Subject: New Clutch Pressure Plate Released for 1962 Corvette

Model and Year: 1957 - 1962 Corvette

Bulletin No: A.I. #62-3

Date: November 28, 1961

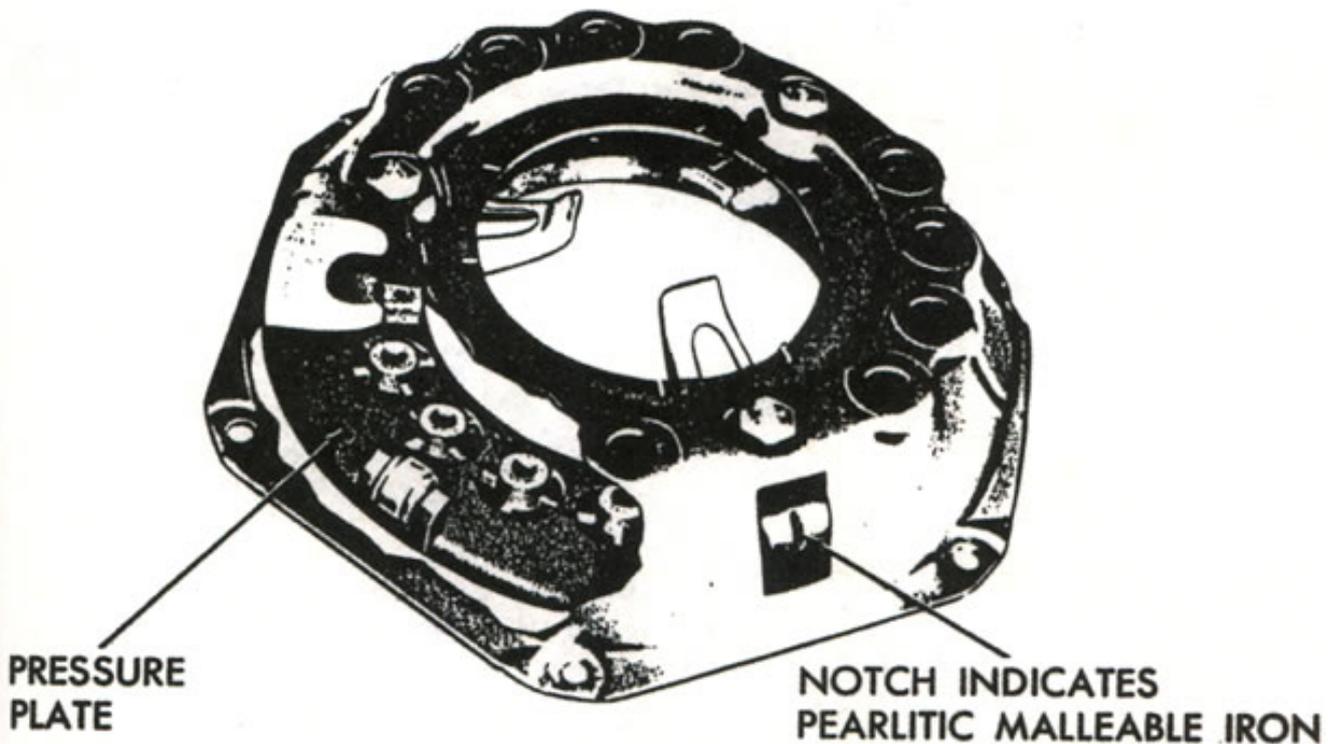
Due to the increased frequency of clutch failures on 1961 High-Performance Corvettes, Engineering has released a new clutch pressure plate made of pearlitic malleable iron in place of the previously used grey cast iron. This new material will provide improved resistance to failure at high RPM's for all mechanical tappet equipped 1962 Corvettes.

The pearlitic malleable iron pressure plate may be identified by a cast depression in each driving lug as shown in Figure 1.

The new pressure plate and the clutch cover-pressure plate assembly are interchangeable with past models from 1957-61. They will be used for service replacement on all 1961 High Performance (RPO 354 and 468) Corvettes as soon as parts are available, and will eventually service all 1957-61 models when present stock of 1961 material is exhausted.
